PROBLEM:

An early H1 may start losing power, misfiring, backfiring, or stop running altogether. Installation of new spark plugs seems to clear up the problem, leaving the impression that the used plugs were defective. However, the problem returns after a short period of use with the new spark plugs.

EARLY H.T. WIRING

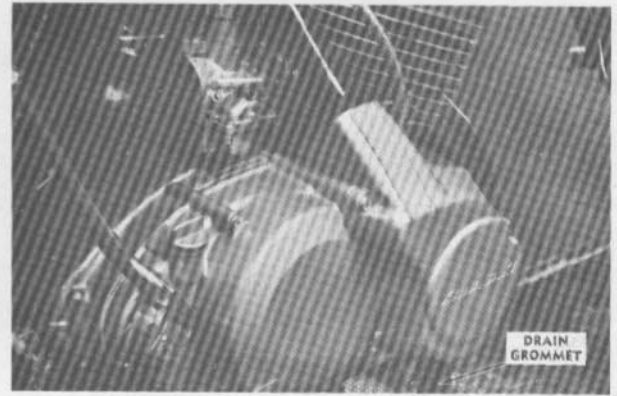
KAWASAKI has developed a set of high tension components which, after thorough testing, has proven completely reliable and eliminates the insulation leakage problem. The purpose of the new components is to re-route the H.T. cords so they are a safe distance from metal engine grounds like the oil pump, oil pump cover, engine cover, cylinders, carburetors, etc. Additionally, the type of H.T. cord has been changed from DAIICHI brand to Belden, a better-insulated cable.

H1 with original H.T. wiring

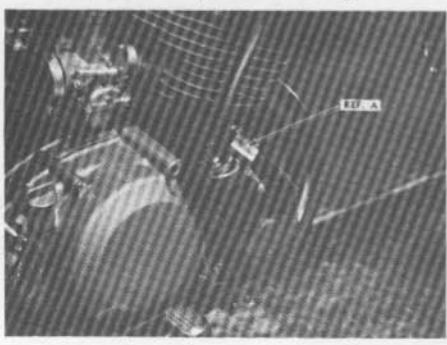
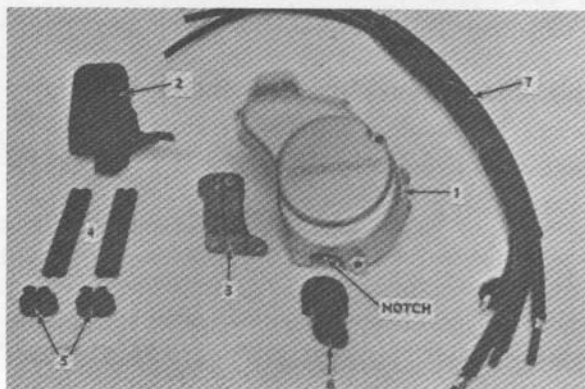
The spark plugs generally are not the cause of the problem. We have found the high tension wiring leaks electricity to adjoining metal engine parts under high voltage loads. New spark plugs require less voltage to fire because the electrodes have sharp edges. As the plugs are used, these sharp edges are rounded off by high energy discharge and erosion from heat and chemical action in the combustion chamber. Consequently, they require an increasing amount of voltage to fire as mileage accumulates. Worn spark plugs, over-rich oil pump settings, or incorrect fuel mixtures demand more voltage from the ignition system to fire the spark plugs. These conditions "back up" the voltage in the secondary wiring until it jumps through the H.T. cord insulation to an inviting engine ground rather than fire the plugs.

The new H.T. components were incorporated on H1's after Engine KAE-08800. The drain grommet was not used until KAE-11300, so on units from KAE-08800 to KAE-11300, the oil pump cover is not notched for the drain grommet.

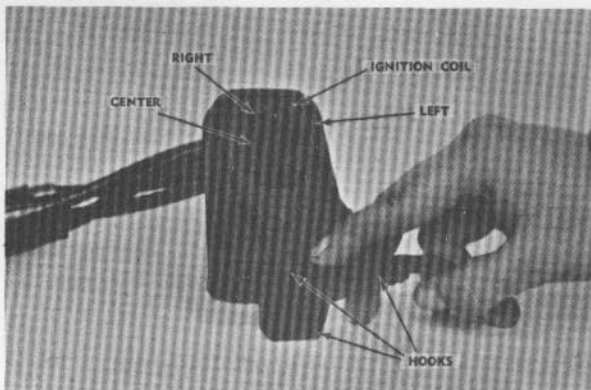
Use Rubber band P/N 92072-013 to fix loom to right frame tube under gas tank.

To save time, use the photo above for inserting the cords in the grommet. The bottom cords should protrude 1" more than the top ones.

To keep water from entering, make sure the bottom of the grommet is hooked onto the crankcase. Route the H.T. cords over the RH carburetor, NOT between the carburetor and cylinder.

Jam the H.T. cords completely into the distributor cap sockets before installing the piercing screws.
